AMENDMENT OF SOLICITATION/MODIFICATION OF CONTRACT				1. CONTRACT ID CODE		PAGE 1 OF 5 PAGES									
2. AMENDMENT/MODIFICATION NO. AMENDMENT NO. 0005		3. EFFECTIVE DATE 04/10/26		4. REQUISITION/PURCHASE REQ. NO.		5. PROJECT NO. (If applicable) 26-0409									
6. ISSUED BY CODE		N40085		7. ADMINISTERED BY (If other than Item 6) CODE											
NAVFAC Mid-Atlantic Resident Officer in Charge of Construction 1107A Birch Street Camp Lejeune, NC 28547-2521				See Item 6											
8. NAME AND ADDRESS OF CONTRACTOR (No., street, county, State and ZIP Code)				(X)		9A. AMENDMENT OF SOLICITATION NO.									
				X		N40085-26-R-9017									
						9B. DATED (SEE ITEM 11) 02/05/26									
						10A. MODIFICATION OF CONTRACT/ORDER NO.									
						10B. DATED (SEE ITEM 11)									
CODE		FACILITY CODE													
11. THIS ITEM ONLY APPLIES TO AMENDMENTS OF SOLICITATIONS															
☒ The above numbered solicitation is amended as set forth in Item 14. The hour and date specified for receipt of Offers ☐ is extended, ☒ is not extended. Offers must acknowledge receipt of this amendment prior to the hour and date specified in the solicitation or as amended, by one of the following methods:

SECTION AT GABLE

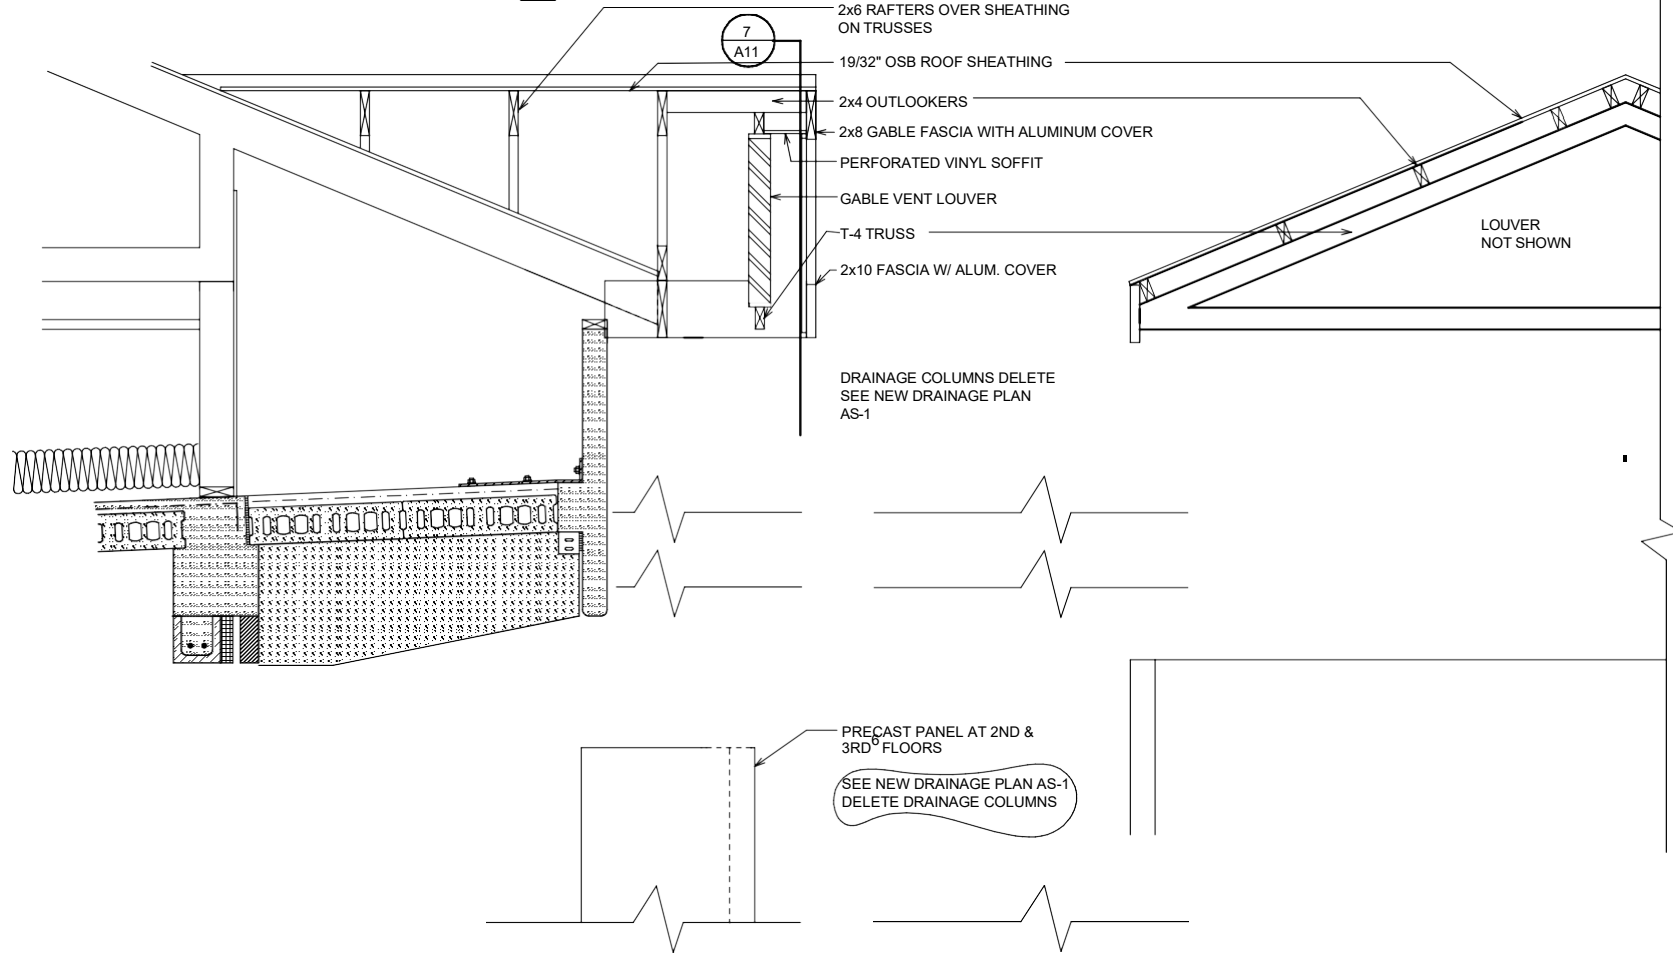
4. **QUESTION:** Note 9 under General Requirements for Building 275, 285, 295 states “Install panel clips as per the manufactures recommendation for a 150 mph Wind in accordance with the Uniform Building Code for North Carolina”. Panel clip spacing based

on the Wind Uplift Calculations takes into consideration the pull-out strength of the roof deck substrate. Does the Government know if the plywood roof decks are 5/8" plywood or 3/4" plywood?

5. **QUESTION:** Note 10 under General Requirements for Building 215, 225, 235, 245 states "Install panel clips as per the manufactures recommendation for a 150 mph Wind in accordance with the Uniform Building Code for North Carolina". Panel clip spacing based on the Wind Uplift Calculations takes into consideration the pull-out strength of the roof deck substrate. Does the Government know if the plywood roof decks are 5/8" plywood or 3/4" plywood?

ANSWER: All Roof sheathing is 19/32" OSB for HP275, HP285, HP295. (See attached existing typical roof detail)

ANSWER: All Roof sheathing is 19/32" OSB for HP215, HP225, HP235, HP245. (See attached existing typical roof detail)

A5 DOWNSPOUT SECTION
SCALE: 1" = 1'-0"

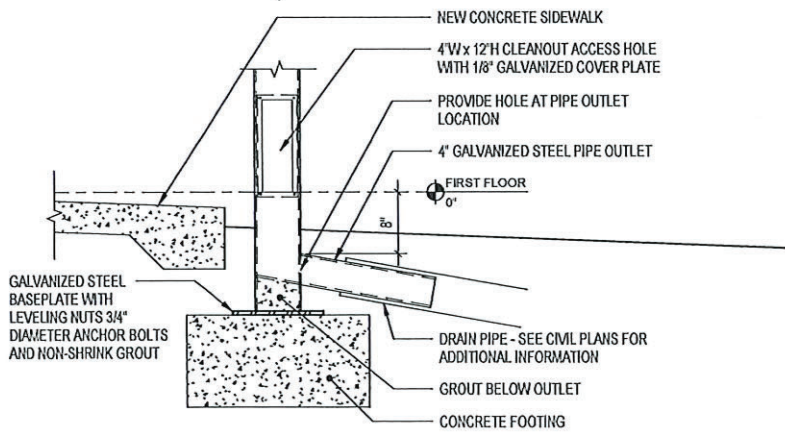
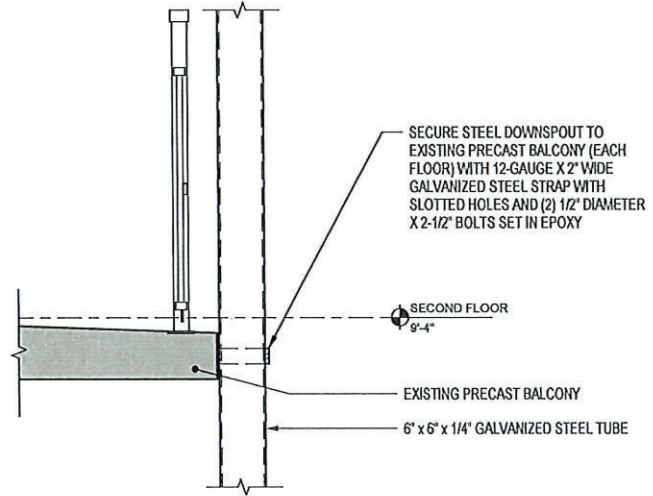
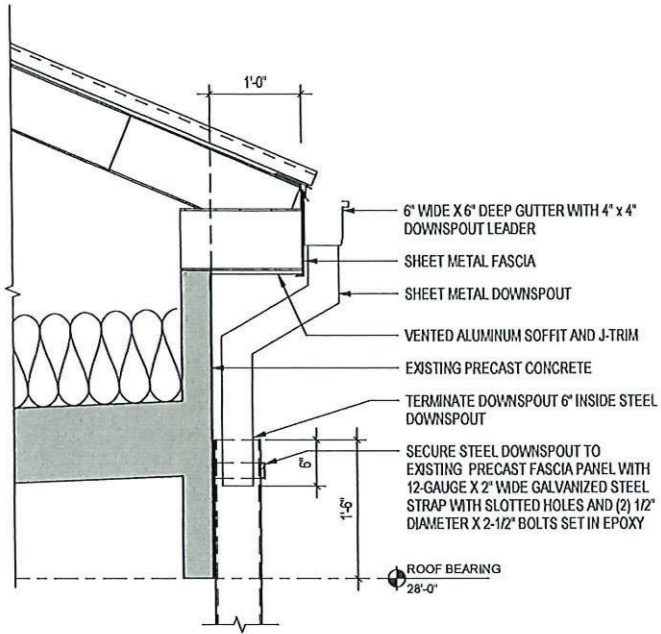
6. **QUESTION:** During our site visit we noticed some differences regarding the downspouts on the 7 different buildings. Building HP-215, 224, 235, 245, 275, and 285 show the downspouts dropping out of the bottom of the gutters, running down the parapet wall about 2 feet and turning back into and through the existing parapet wall piping the rainwater back into the building into pvc piping installed in the attic. Our experience over the last 10 to 15 years has included provisions in the contract drawings to provide 6"x6"x1/4" Steel Downspouts to channel the water out of the building down and tying into a rain leader below grade. The Tubular Steel provides protection of the downspout from potential damages that could crush or bend the typical light gauge aluminum downspouts.

There is currently no work included in this projects scope of work to do anything with the existing gutters and downspout's other than to clean them. Does the government want to leave the downspouts turning back into the attic space or are 6X6 tubular steel downspouts needed on these 6 buildings?

ANSWER: Please proceed with the install of the requested 6x6 tubular steel downspouts on these 6 buildings. The detail mention for typical Tubular Steel DS will suffice. (HP215, HP225, HP235, HP245, HP275, HP285).
